UNITED STATES PATENT AND TRADEMARK OFFICE

Office Action Summary	Application No. 10/526,564	Applicant(s) YAMAGUCHI, TAKUMI	
	Examiner Benjamin T. Liu	Art Unit 2826

DETAILED ACTION

Figure 1: solid-state imaging apparatus with pixel 41'

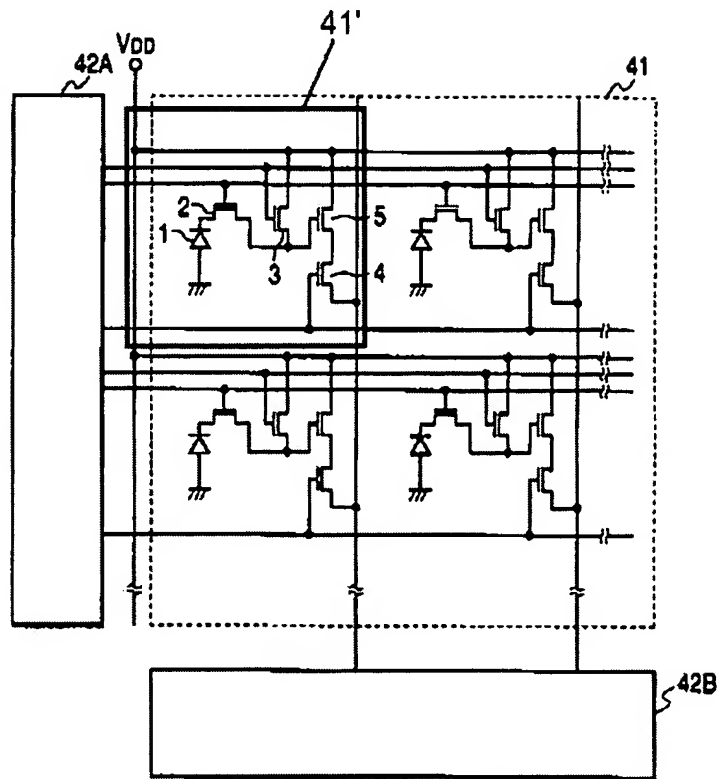
With regard to claim 1, figures 1 and 11 of Yuzurihara et al. disclose a solid-state imaging apparatus that includes an imaging region 41 and a drive circuit region 42 both formed on one semiconductor substrate, the imaging region 41 including an active-type unit pixel 41' in which a photodiode unit 1 generates signal charge by photoelectric conversion and an amplification unit 5 amplifies the signal charge, the drive circuit region 42 being for driving the photodiode unit 1 and the amplification unit 5, the imaging region 41 and the drive circuit region 42 including one or more transistors respectively, wherein the transistors in the imaging region 41 and the drive circuit region 42 have a same channel polarity. (Note lines 1-2 in paragraph [0076] of Yuzurihara et al.)

Figures 1 and 11 of Yuzuihara et al. does not discloses all the transistors in the imaging region and the drive circuit region have a same channel polarity.
